# 2

## Description of Proposed Changes

## 2.2 Proposed Refinements to Project Design

Figure 2-13: Cross Sections – South Square Station  
(Previous Design at Left; Proposed Refinements at Right)

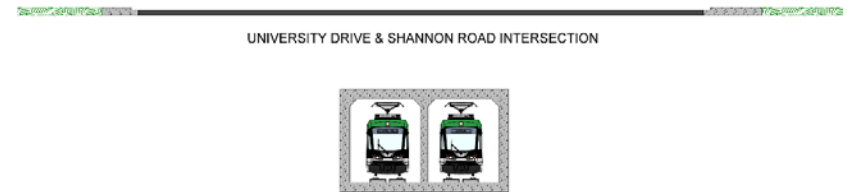
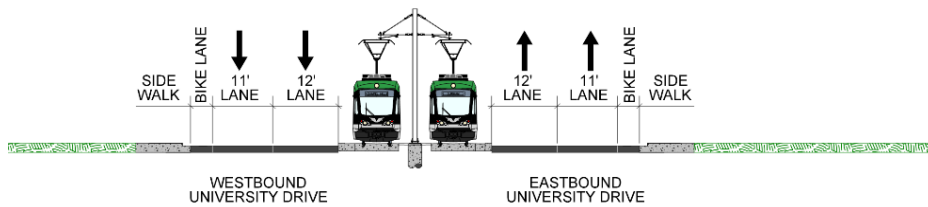
Location	What's Changed?	Why?
<p>South Square Station                      (Figures 2-12, 2-13 and appendix A-2, Sheet 19)</p>	<ul style="list-style-type: none"> <li>▪ Revised the alignment through the intersection of University Drive and Shannon Road to pass underneath the intersection in an underpass instead of crossing through the intersection at-grade.</li> <li>▪ Revised the location of the station approximately 220 feet to the south, locating the station at-grade south of Auto Drive, instead of elevated north of Auto Drive.</li> <li>▪ Maintained access from the new park-and-ride lot to Shannon Road.</li> <li>▪ Added 350 new park-and-ride spaces (for total of approximately 600 spaces) on portions of parcels identified as acquisitions for the track alignment and park-and-ride in the Previous Design.</li> <li>▪ Identified the South Square Station park-and-ride site as a potential joint development site. At this time, the Proposed Refinements do not include activities or improvements specifically tied to a joint development project; rather, the design refinements include acquisition and site preparation for a park-and-ride facility that may also support a future joint development (redevelopment).</li> </ul>	<ul style="list-style-type: none"> <li>▪ In the Amended ROD, GoTriangle committed to incorporate roadway safety measures into the design refinements, such as shifting the light rail alignment horizontally or vertically away from vehicular traffic (Mitigation ID # R04). The underpass design in the Proposed Refinements eliminates a complex at-grade crossing through the intersection of University Drive and Shannon Road.</li> <li>▪ Additional parking is more consistent with projected park-and-ride demand in this portion of the corridor.</li> <li>▪ Since publication of the Amended ROD, GoTriangle has engaged a task force of local stakeholders, including representatives from local governments, regional agencies, and the Durham Housing Authority, to identify potential joint development sites in the D-O LRT Project Corridor. The task force identified and evaluated over 30 potential sites and recommended four sites for further study, including the South Square Station park-and-ride.</li> </ul>

Figure 2-17: Illustration of Proposed Refinements – LaSalle Street Station

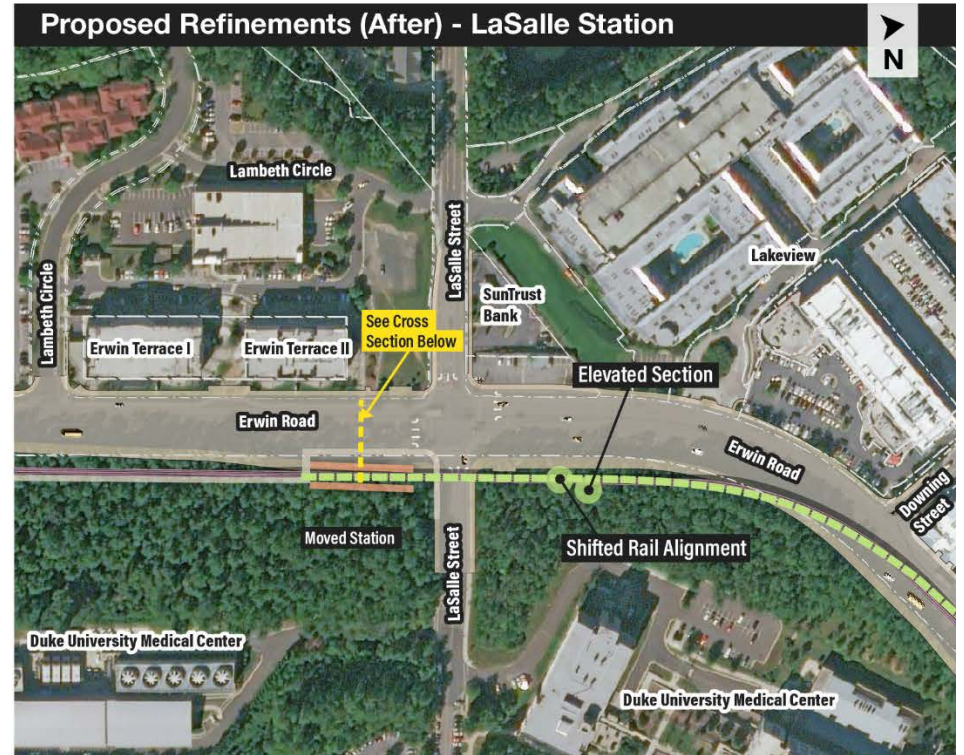
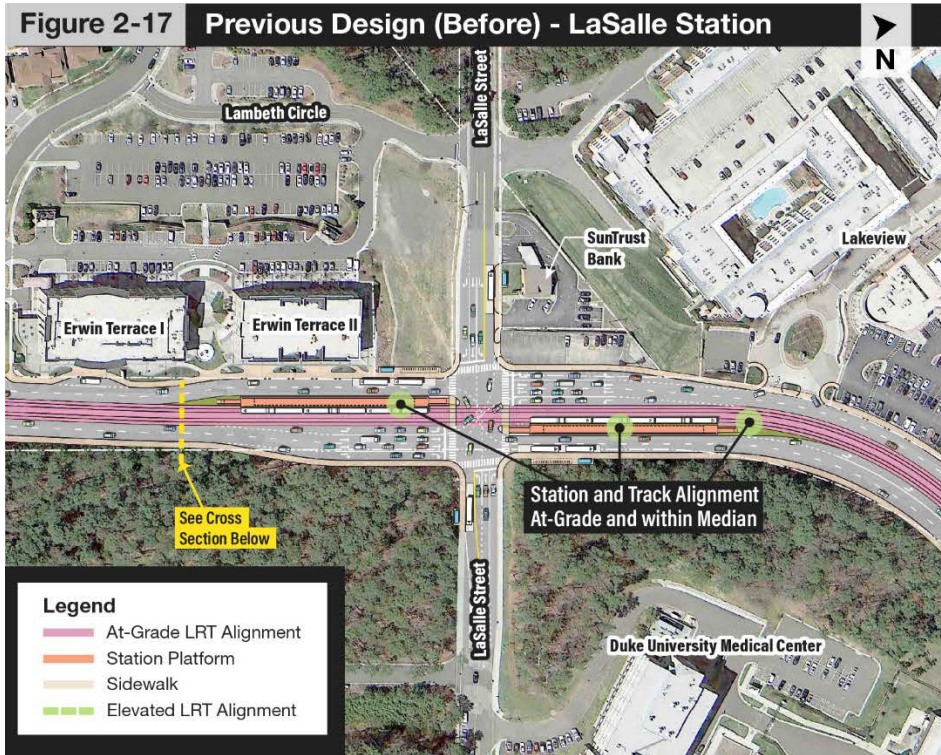
Location	What's Changed?	Why?
<p>Erwin Road and Duke/VA Medical Centers                      (Figures 2-17 to 2-21 and appendix A-3, Sheets 23 - 26)</p>	<ul style="list-style-type: none"> <li>▪ Revised the track alignment from south of Cameron Boulevard to NC 147 from a street-level median-running alignment to a combination of at-grade side-running and elevated median-running alignment, as follows:                             <ul style="list-style-type: none"> <li>○ Shifted the rail alignment from the median of Erwin Road at the intersection of Cameron Boulevard to the southeast side of Erwin Road.</li> <li>○ The alignment transitions from ground level to elevated structure just southwest of LaSalle Street, remains elevated and transitions into the median of Erwin Road, shifts out of the median on the north side of Erwin Road, just east of Flowers Drive, remaining elevated to the Ninth Street Station.</li> </ul> </li> <li>▪ Moved the LaSalle Street Station to the south side of Erwin Road, elevated on retained fill.</li> <li>▪ Moved the Duke/VA Medical Centers Station from between Trent and Flowers Drives in the Previous Design to just west of Fulton Street. The elevated structure provides direct access to the platform from the sidewalks.</li> </ul>	<ul style="list-style-type: none"> <li>▪ In the Amended ROD, GoTriangle committed to perform additional engineering design work to avoid or limit impacts to existing utilities (Mitigation ID # UI01). The changes would avoid the need to relocate a major high-voltage (44kV) electrical transmission line under Erwin Road that provides power to the Duke University and Durham VA hospital complexes, thereby reducing risk to electrical service interruption at the hospitals and a substantial cost to relocate a major high-voltage electrical transmission line.</li> <li>▪ In the Amended ROD, GoTriangle committed to coordinate with emergency and medical personnel during design advancement to investigate impacts of the light rail system on their day-to-day operations (Mitigation ID # SS01). VA and Duke University Medical Centers personnel encouraged GoTriangle to refine the design to an elevated alignment through the hospitals area to eliminate potential conflicts with ambulances crossing and traveling along the light rail corridor.</li> <li>▪ In the Amended ROD, GoTriangle committed to incorporate roadway safety measures into the design refinements, such as shifting the light rail alignment horizontally or vertically away from vehicular traffic (e.g., shifting to side-running from median-running), and installing elevated structures to avoid significant impacts on existing roads (Mitigation ID # R04).</li> </ul>

Location	What's Changed?	Why?
Erwin Road and Duke/VA Medical Centers (Cont'd) (Figures 2-17 to 2-21 and appendix A-3, Sheets 23 - 26)		<ul style="list-style-type: none"> <li>■ In the Amended ROD, GoTriangle committed to continue coordination with Duke University on relocating and maintaining services provided at the John Hope Franklin Center (Mitigation ID # NCR02); the changes would avoid impacts to the John Hope Franklin Center and eliminate the need for its relocation.</li> <li>■ In the Amended ROD, GoTriangle committed to refine the design to enhance sidewalk connections and improve bicycle and pedestrian access to stations (Mitigation ID # PBF01); the changes provide enhanced access to stations as compared to the Previous Design by locating the LaSalle Street station on the side of Erwin Road and the Duke/VA Medical Centers station on an elevated structure with direct access to the platform from the sidewalks.</li> </ul>

**Figure 2-22: Illustration of Proposed Refinements – Ninth Street Station**

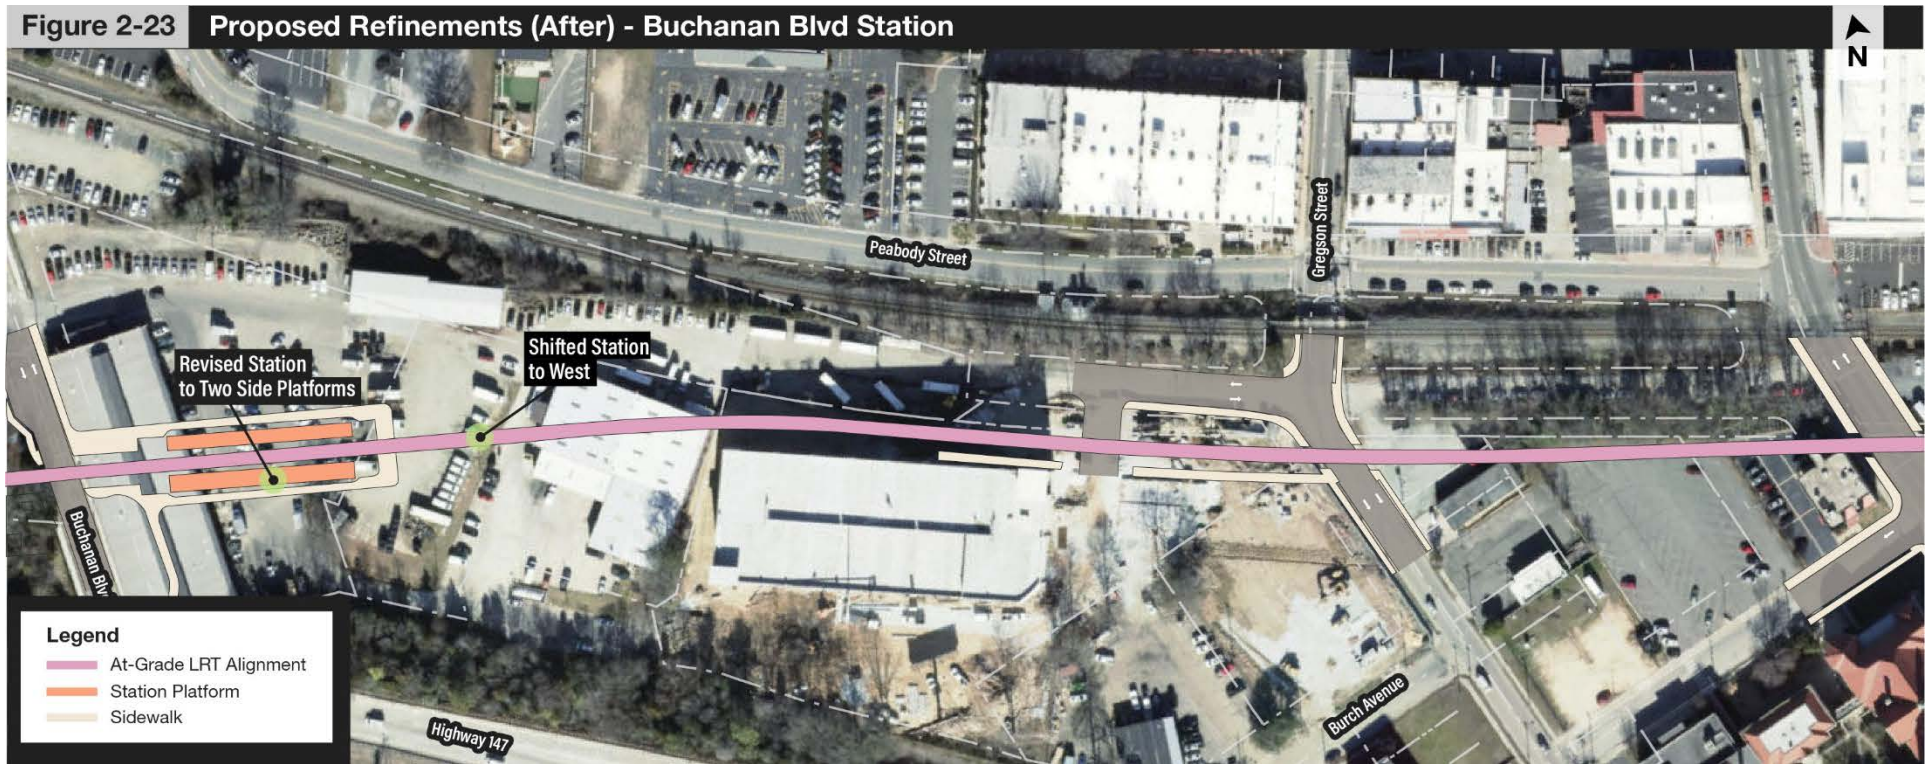
Location	What's Changed?	Why?
Ninth Street Station (Figure 2-22 and appendix A-3, Sheets 26, 27)	<ul style="list-style-type: none"> <li>Shifted the location of the elevated station to the east approximately 220 feet to straddle Erwin Road, allowing direct pedestrian access from both the east and west sides of the street.</li> <li>Added a sidewalk on the south side of Pettigrew Street from Erwin Road to Swift Avenue.</li> </ul>	<ul style="list-style-type: none"> <li>In the Amended ROD, GoTriangle committed to refine the design to enhance sidewalk connections and improve bicycle and pedestrian access to stations (Mitigation ID # PBF01).</li> </ul>

**Figure 2-24: Illustration of Proposed Refinements –Blackwell/Mangum Streets Station**

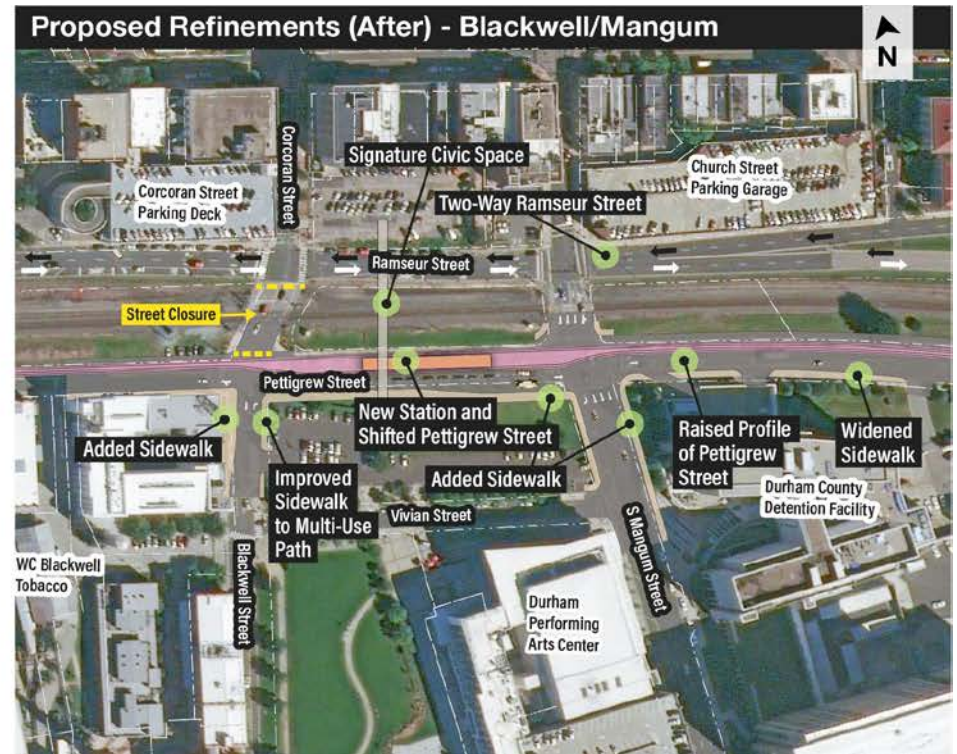
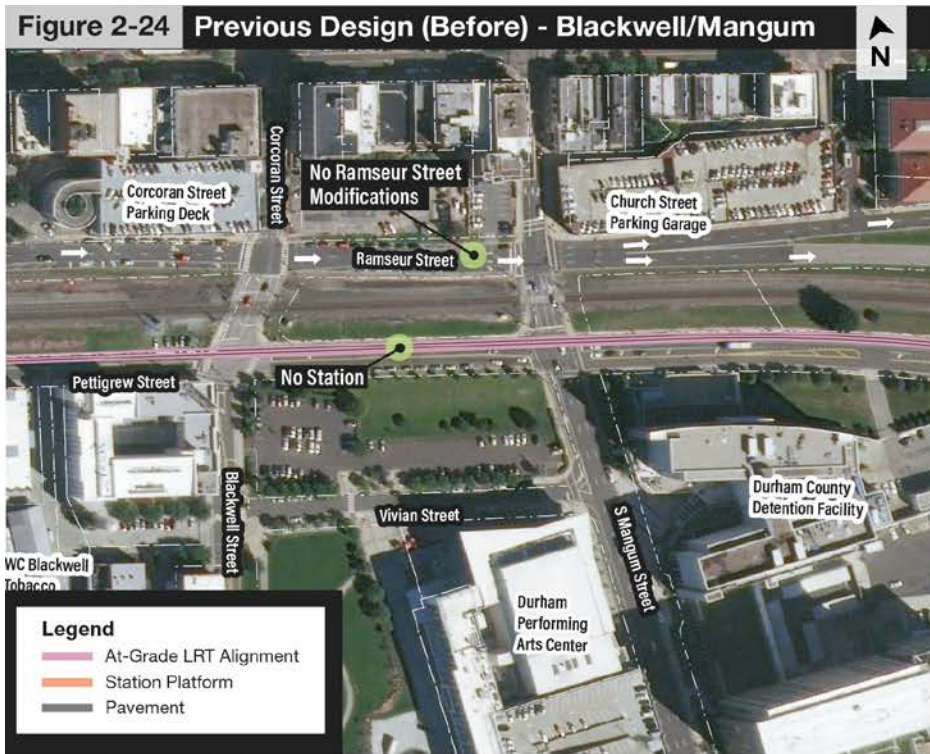
<p>Blackwell/Mangum Streets Station (<b>Figure 2-24 and appendix A-3, Sheets 29 – 31</b>)</p>	<ul style="list-style-type: none"> <li>Added the proposed Blackwell/Mangum Streets Station, a center platform station near the Durham Performing Arts Center (DPAC), between Blackwell Street and Mangum Street. This required shifting Pettigrew Street to the south approximately 10 feet, and raising the street profile.</li> <li>Improved multi-use path on the east side of Blackwell Street from Pettigrew Street to Vivian Street and widened a sidewalk on Pettigrew Street from Blackwell Street to Chatham Place.</li> <li>Reconfigured Ramseur Street to permit two-way operations between Chapel Hill Street and Dillard Street.</li> <li>Closed Blackwell Street to vehicle and pedestrian access between Ramseur Street and Pettigrew Street.</li> <li>Raised the profile of Pettigrew Street and the intersecting streets between Blackwell Street and Grant Street.</li> <li>Added a signature civic space connecting Pettigrew Street to Ramseur Street approximately mid-block between Blackwell Street and Mangum Street.</li> </ul>	<ul style="list-style-type: none"> <li>In response to public comments and comments received from the City of Durham, GoTriangle committed to study the addition of a proposed station near Blackwell and Mangum Streets (Combined FEIS/ROD appendix D.3). The proposed station would meet the project goal of providing direct service to key destinations in downtown Durham.</li> <li>In the Amended ROD, GoTriangle committed to refine the design to enhance sidewalk connections and improve bicycle and pedestrian access to stations (Mitigation ID # PBF01).</li> <li>In the Amended ROD, GoTriangle committed to coordinate with NCRR, Norfolk Southern, and NCDOT regarding safety measures near at-grade rail and roadway crossings (Mitigation ID # R04, SS01). Due to the steep grade separation, the Previous Design would have created a safety and feasibility issue for large vehicles (e.g., lowboy trailers) attempting to cross both the railroad and light rail tracks. Raising the profile of Pettigrew Street from Blackwell Street to Grant Street would improve the grade crossings. The closure of Blackwell Street is due to the severity of the grade difference across the tracks and the resultant impacts to the Old Bull Building, a Historic National Landmark. The closure of Blackwell Street also addresses a gate operations signaling issue.</li> <li>Conversion of Ramseur Street to two-way operations allows bus traffic to relocate from the westbound light rail alignment between Dillard Street and Chapel Hill Street and to travel westbound on Ramseur Street.</li> </ul>

Location	What's Changed?	Why?
Blackwell/Mangum Streets Station (cont'd) (Figure 2-24 and appendix A-3, Sheets 29 – 31)		<ul style="list-style-type: none"> <li>In order to maintain pedestrian access to downtown Durham across the NCCR Corridor, and to the proposed Blackwell/Mangum Street Station, a signature civic space is proposed to connect Pettigrew Street and Ramseur Street.</li> </ul>

Figure 2-25: Illustration of Proposed Refinements – Dillard Street Station

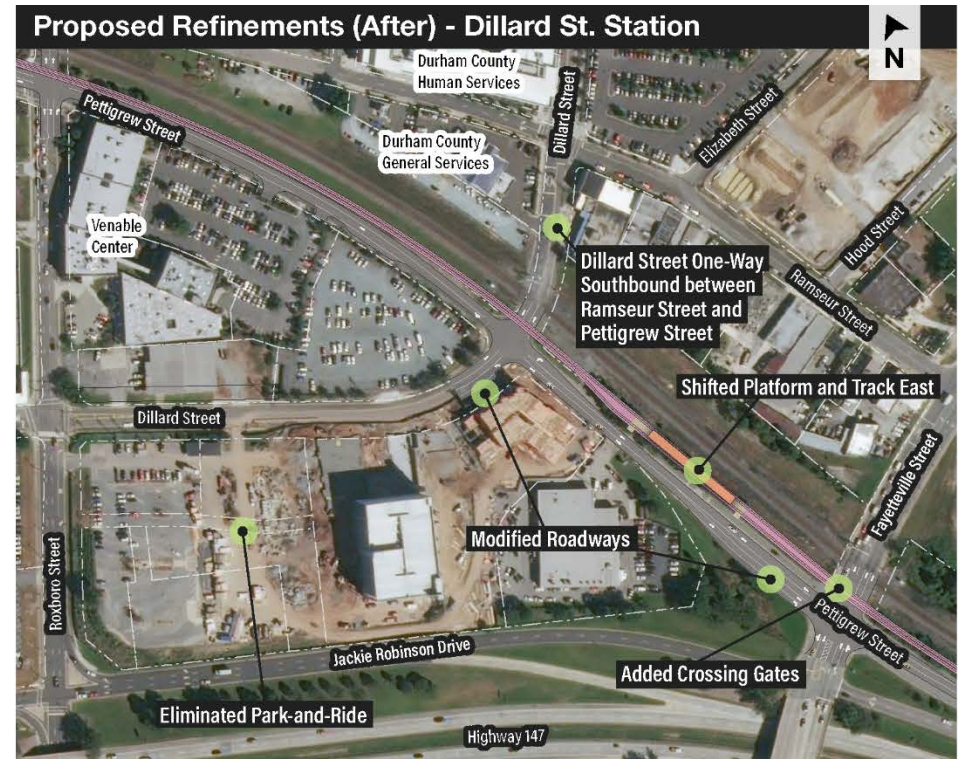
Location	What's Changed?	Why?
Dillard Street Station (Figure 2-25 and appendix A-3, Sheet 30)	<ul style="list-style-type: none"> <li>▪ Eliminated park-and-ride at the Dillard Street Station.</li> <li>▪ Modified the roadway design: removed a lane along Pettigrew Street adjacent to the station platform (reducing from the three lanes in the Previous Design to two lanes), and widened Pettigrew Street for left and right turn lanes at Fayetteville Street.</li> <li>▪ Converted Dillard Street to one-way southbound operations between Ramseur Street and Pettigrew Street.</li> <li>▪ Shifted the platform and the track alignment to the east to accommodate a longer westbound right turn along Pettigrew Street.</li> <li>▪ Added gates to light rail crossing adjacent to railroad crossing at Fayetteville Street.</li> </ul>	<ul style="list-style-type: none"> <li>▪ A private developer redeveloped the site identified as a park-and-ride with an apartment complex and plans for additional commercial buildings. GoTriangle can no longer pursue a cost-effective park-and-ride lot at this location.</li> <li>▪ Through coordination with the City of Durham and the private developer at this site, GoTriangle recognized that the Previous Design would significantly affect the available footprint for the private development and that raising the grade of Pettigrew Street as planned in the Previous Design would conflict with the building frontage, negatively affecting pedestrian circulation and access between the development and the station. The changes would improve the interface between the development and the station.</li> </ul>

Figure 2-26: Illustration of Proposed Refinements – Alston Avenue/NCCU Stations

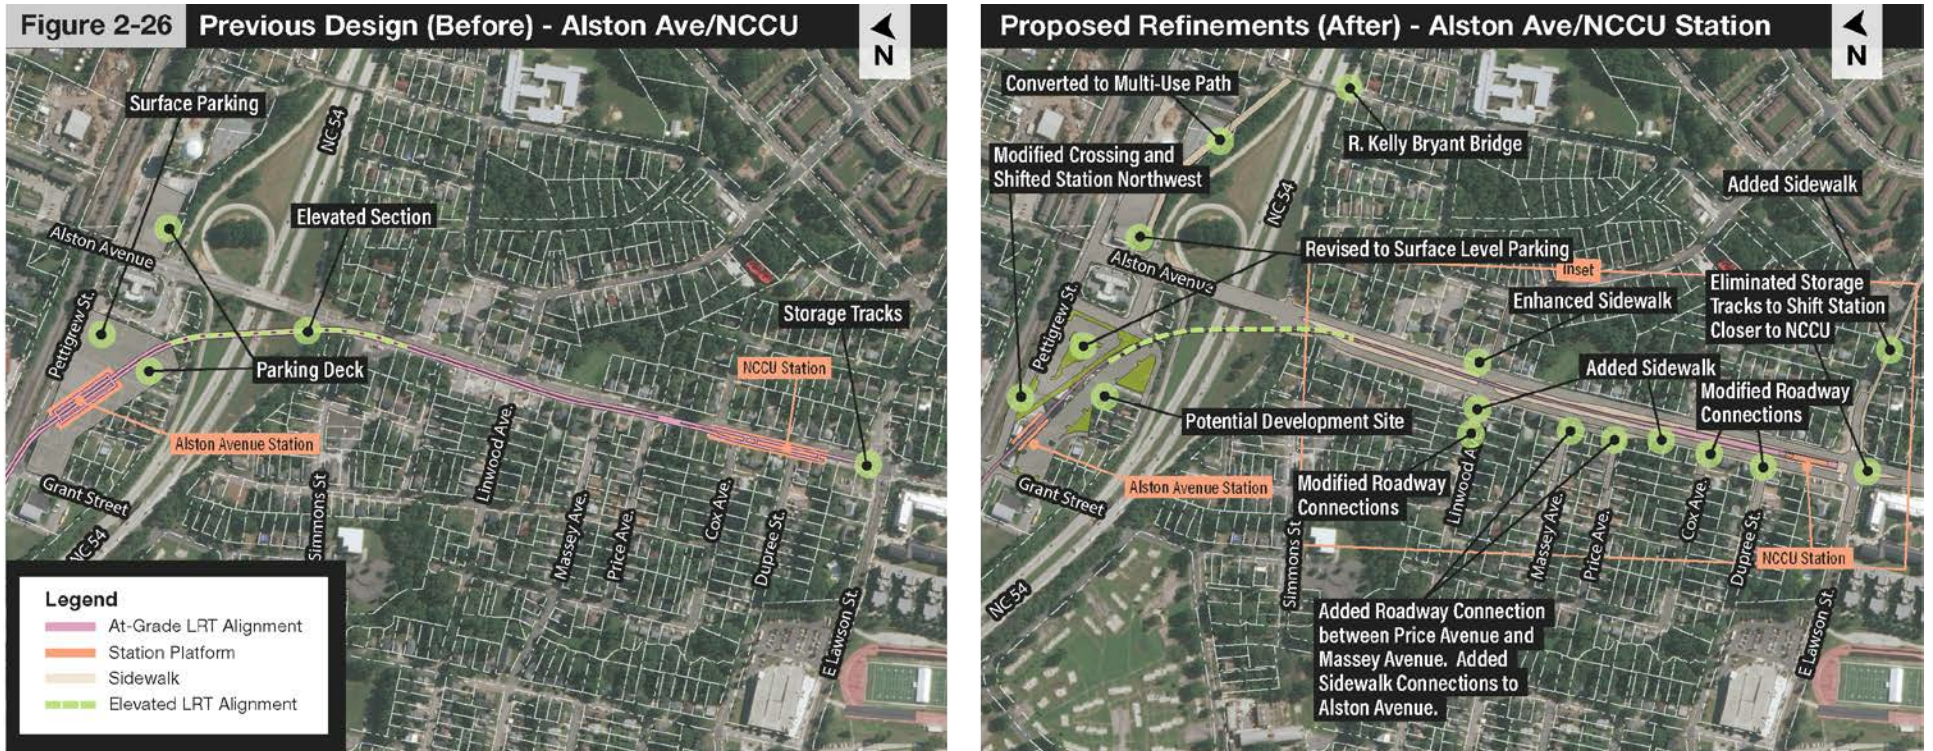
Location	What's Changed?	Why?
<p>Alston Avenue Station                      (Figure 2-26 and appendix A-3, Sheet 31)</p>	<ul style="list-style-type: none"> <li>▪ Changed the park-and-ride parking layout from a parking garage and surface lot to multiple surface parking lots.</li> <li>▪ Reconfigured the at-grade crossing of Pettigrew Street and moved the station platform closer to the intersection of Pettigrew Street and Grant Street to improve pedestrian access to the station.</li> <li>▪ Converted the existing path between the R. Kelly Bryant Bridge and Alston Avenue just north of NC 147 to a multi-use path, including lighting and wayfinding.</li> <li>▪ Identified the Alston Avenue Station park-and-ride as a potential joint development site. At this time, the Proposed Refinements do not include activities or improvements specifically tied to a joint development project; rather, the design refinements include acquisition and site preparation for a park-and-ride facility that may also support a future joint development (redevelopment).</li> </ul>	<ul style="list-style-type: none"> <li>▪ The surface parking configuration is more cost effective and is better aligned with other planned park-and-ride parking.</li> <li>▪ GoTriangle refined the design in response to the City of Durham's request to improve pedestrian access and reduce vehicular conflicts between the light rail system and the roadway operations. This refinement is consistent with GoTriangle commitments in the Amended ROD (Mitigation ID #s LUZ01, NCR02, EJ01, R07, R04).</li> <li>▪ The refinements would result in direct access to existing and future planned development along Grant Street.</li> <li>▪ GoTriangle enhanced the pedestrian route to meet its commitments in the Amended ROD (Mitigation IDs # PBF01, PBF03).</li> <li>▪ This refinement would mitigate the loss of opportunity for on-street bicycle facilities on Alston Avenue with improvements to off-street facilities (Mitigation IDs #PBF05).</li> <li>▪ Since publication of the Amended ROD, GoTriangle engaged a task force of local stakeholders, including representatives from local governments, regional agencies, and the Durham Housing Authority, to identify potential joint development sites in the D-O LRT Project Corridor. The task force identified and evaluated over 30 potential sites and recommended four sites for further studies along the alignment, including the Alston Avenue Station park-and-ride.</li> </ul>
